REF 1 ADDENDUM

REF 2 ADDENDUM

DRAWING NAME
GENERAL ARRANGEMENT PLAN

PROJECT
JINDABYNE EDUCATION CAMPUS
207 BARRY WAY JINDABYNE
REVIEW OF ENVIRONMENTAL FACTORS

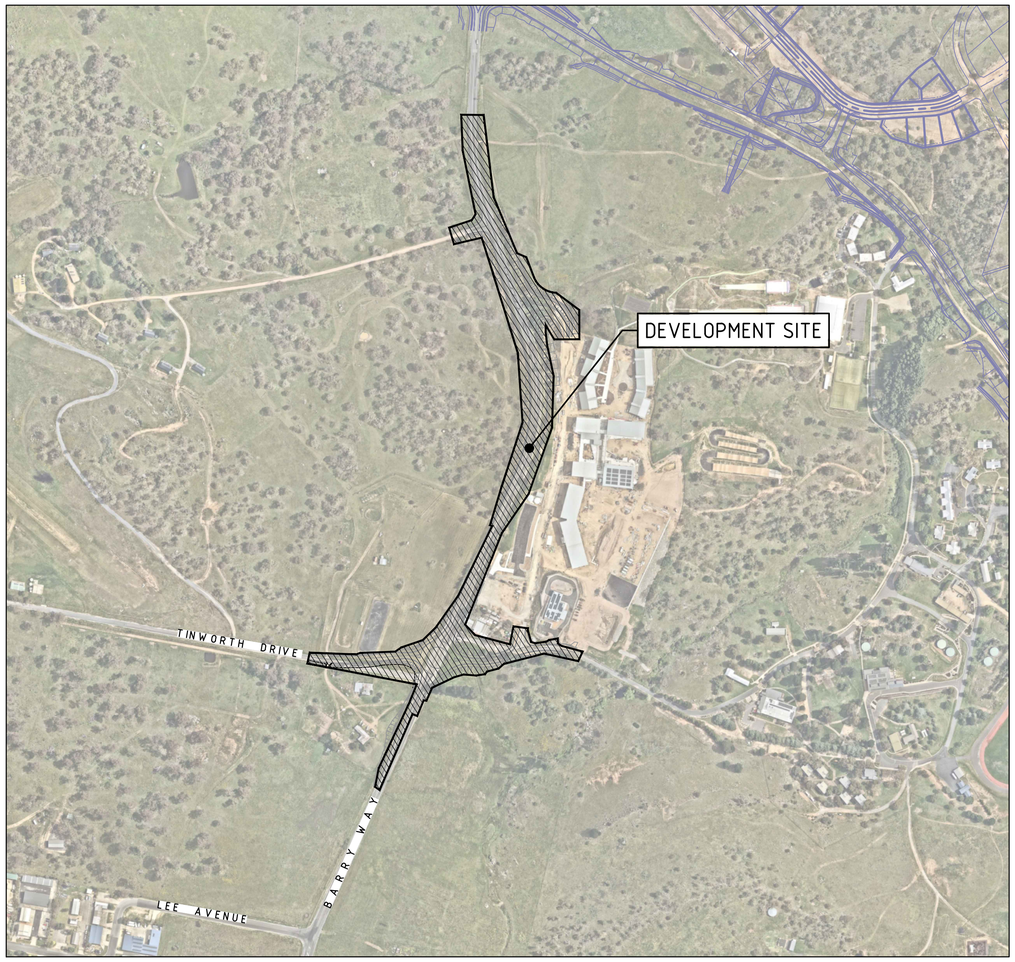
- AMENDMENTS TO THE APPROVED ROAD DESIGN, INCLUDING, BUT NOT LIMITED TO, REPLACEMENT OF A PROPOSED RETAINING WALL WITH BATTERING WITHIN LOT 1 DP 1294413.
- AMENDMENTS TO THE APPROVED STORMWATER DESIGN TO IMPROVE PIPE PROTECTION AND MAINTENANCE ARRANGEMENTS.
- NCLUSION OF WATER MAIN AND TELECOMMUNICATIONS INFRASTRUCTURE RELOCATION WORKS UNDER THE REF. THE WORKS WILL INVOLVE A COMBINED SERVICES TRENCH WHICH IS BEING RELOCATED FROM THE EAST TO THE WEST SIDE OF BARRY WAY.
- REMOVAL OF THREE ADDITIONAL TREES.
- EXPANSION OF THE PROJECT AREA INTO LOT 1 DP 1294413, AS NECESSITATED BY THE PROPOSED CHANGES.
  AMENDMENT TO APPROVED CONSTRUCTION HOURS.
  MINOR AMENDMENTS TO MITIGATION MEASURES.

- AMENDMENTS TO THE APPROVED ROAD DESIGN, INCLUDING, BUT NOT LIMITED TO ADDITIONAL WORKS IN LOT 192 DP 1019526 TO ACCOMMODATE A REVISED SOUTHERN APPROACH TO THE PROPOSED ROUNDABOUT.

- AMENDMENTS TO THE APPROVED STORMWATER DESIGN TO IMPROVE PIPE PROTECTION AND MAINTENANCE ARRANGEMENTS.
- INCLUSION OF WATER MAIN AND TELECOMMUNICATIONS INFRASTRUCTURE RELOCATION WORKS UNDER THE REF. THE WORKS WILL INVOLVE A COMBINED SERVICES TRENCH WHICH IS BEING RELOCATED FROM THE EAST TO THE WEST SIDE OF BARRY WAY.

- INCLUSION OF SEWER DIVERSION WORKS UNDER THE REF. THE SEWER DIVERSION WORKS ARE PROPOSED FROM THE ROUNDABOUT ALONG THE JINDABYNE SPORT AND RECREATION CENTRE ACCESS ROAD.

- REMOVAL OF TWO ADDITIONAL TREES.
- EXPANSION OF THE PROJECT AREA INTO LOT 192 DP 1019526 AND LOT 2 DP 1294413, AS NECESSITATED BY THE PROPOSED CHANGES.

- AMENDMENT OF APPROVED CONSTRUCTION HOURS.
- MINOR AMENDMENTS TO MITIGATION MEASURES.
